Report: TAB Report
Function: Test, Adjust, & Balance
Date: 01/28/2026
Completed By: National TAB

02-16-26 WHATABURGER #1687 LUTZ, FL

Issue List

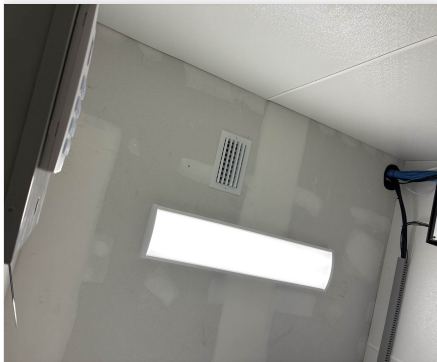
Issue Name : Additional Diffuser - RTU 3 office
Description : An additional diffuser was installed in office. There was an existing supply flex duct run blowing above ceiling in which the MC tapped into. Currently, damper is fully closed and grill reads 75 CFM. Unable to balance without a CFM target. Recommend engineer review.
Created By : National TAB **Assigned To :** National TAB - Will Turnbough
Status : Open
Priority : Urgent **Asset Tag :**
Originated Date : 02/19/2026 - Jackson Gunnels - National TAB

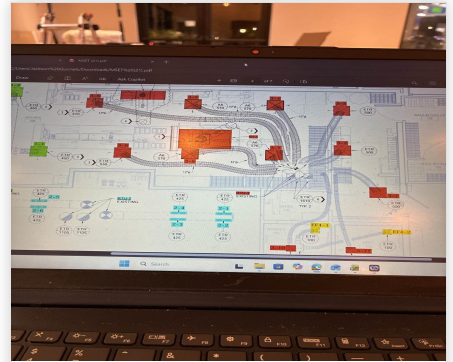
Issue Name : Exhaust fans - Incorrect Locations
Description : Exhaust fans are mounted on wrong curbs. Unable to balance fans in current state. EF-1 (larger fan) also leaks around curb.
Created By : National TAB **Assigned To :** National TAB - Will Turnbough
Status : Open
Priority : Urgent **Asset Tag :**
Originated Date : 02/19/2026 - Jackson Gunnels - National TAB

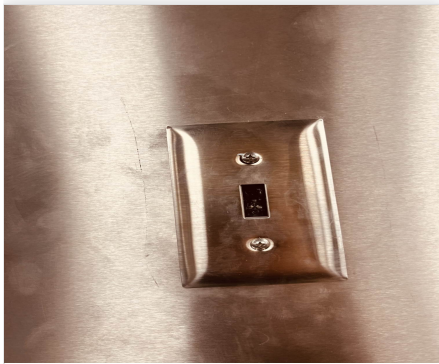
Issue Name : High Humidity Recorded
Description : Space is very humid, measured at %68 relative humidity. NTi noticed units were not cooling the space effectively. Cleaning evaporator coils may improve their efficiency.
Created By : National TAB **Assigned To :** National TAB - Will Turnbough
Status : Open
Priority : InfoOnly **Asset Tag :**
Originated Date : 02/19/2026 - Jackson Gunnels - National TAB

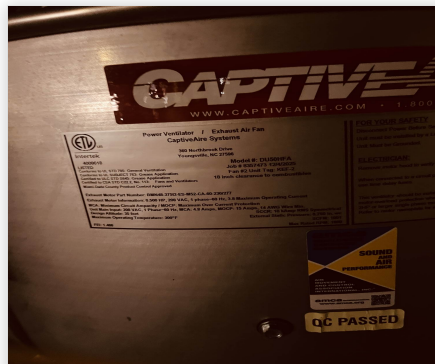
Issue Name : KEFs make and model
Description : MSET indicates Greenheck Units to be installed. Current units are Captive Aire models DU180HFA and DU50HFA
Created By : National TAB **Assigned To :** National TAB - Brianna Biggs
Status : Closed
Priority : InfoOnly **Asset Tag :**
Originated Date : 02/19/2026 - Jackson Gunnels - National TAB

- **02/19/2026 National TAB - Stephen Tassinaro**
 - Substitution matches design criteria

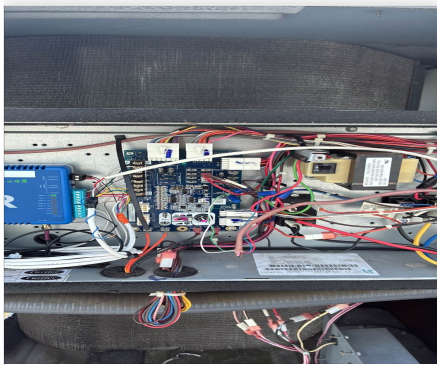
Issue Name : Restroom supply dampers
Description : Parallel blade dampers installed in restroom supply only reduce airflow by half when fully closed, recommend OBDs be installed.
Created By : National TAB **Assigned To :** National TAB - Will Turnbough
Status : Open
Priority : Urgent **Asset Tag :**
Originated Date : 02/19/2026 - Jackson Gunnels - National TAB

Screenshot of the GRD marked up with supply and return traverse locations for RTU-1 (Add picture here)

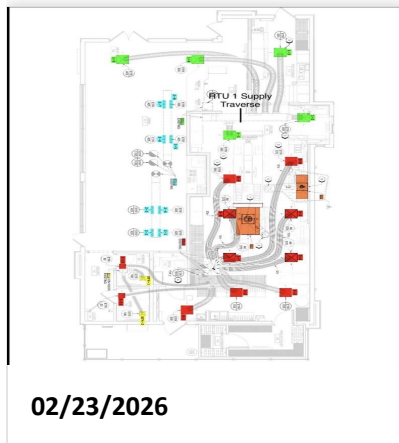
Return traverse not possible.

Asset: RTU-3

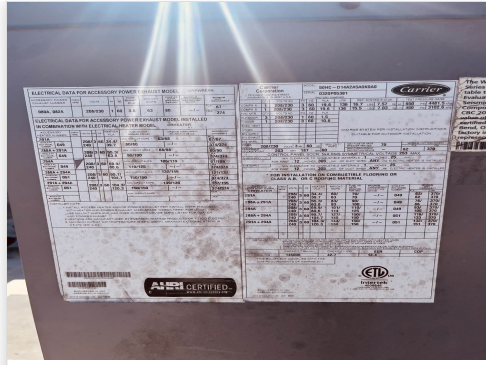
Notes:
Fan sheave sits further out than motor sheave
